Bulletin Type.....: **Safety Recall**

Bulletin No.....: TS-S129

Bulletin Name.....: Nozzle Replacement

Subject:Firetrace fire suppression system nozzle replacement

FOR DOT SYSTEMS (SYSTEMS USING NOZZLE P/N 500002 AS SHOWN ABOVE):

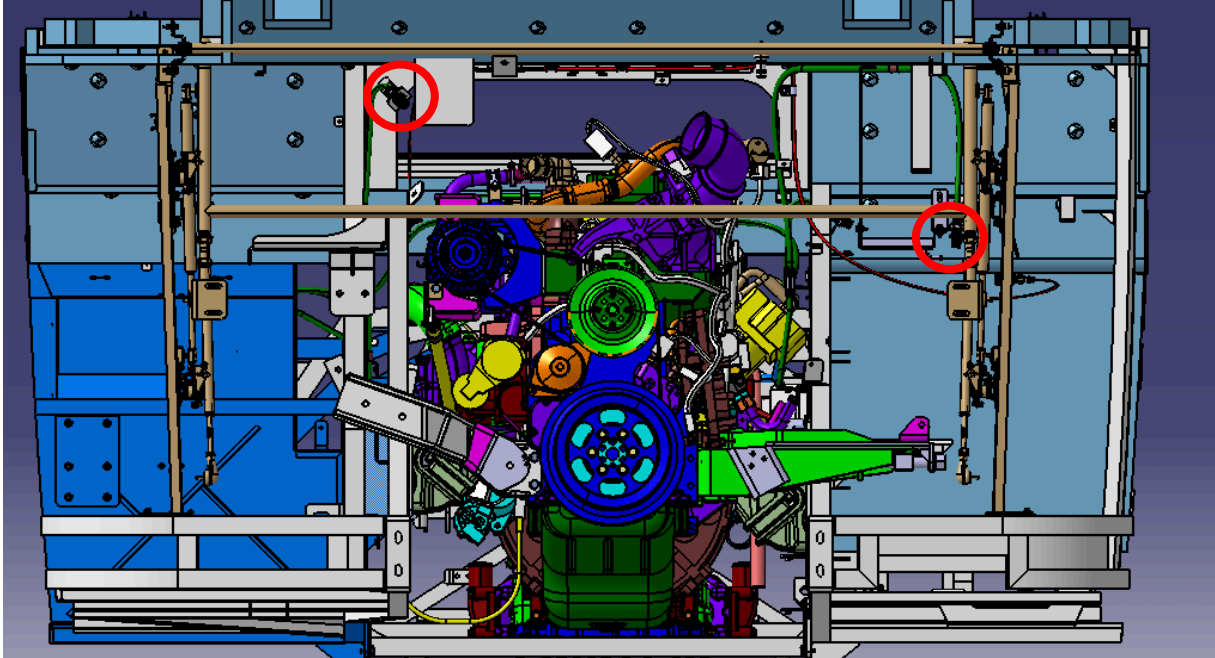
The kit contains either 2 or 4 nozzles per the system design (no adapters are required).

1. Remove the existing nozzle with a spanner (wrench) to remove the nozzle from the fitting whilst clamping the fitting to avoid disturbing other connections. Discard the nozzle.
2. (If applicable) Remove and RETAIN the rubber cap on the nozzle.
3. Install the nozzle using PTFE tape on the male connection. Use care to secure the fitting while tightening the nozzle on to the fitting, hand tight plus 1.5 turns.
4. (If applicable) The nozzle cap may then be reinstalled by first sliding the tether over the nozzle and then placing the cap in place over the nozzle.

*Engine bay area;

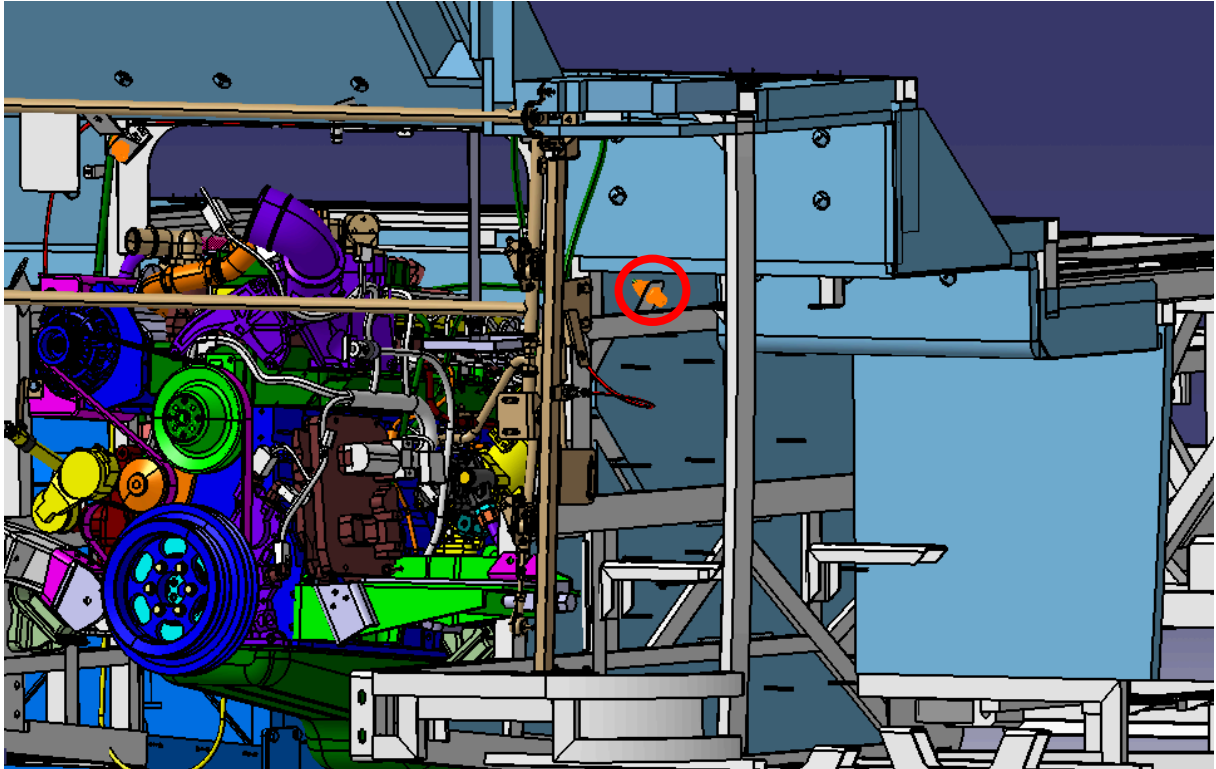
Locations of the 4 nozzles for TS30 vehicle are shown as follow;
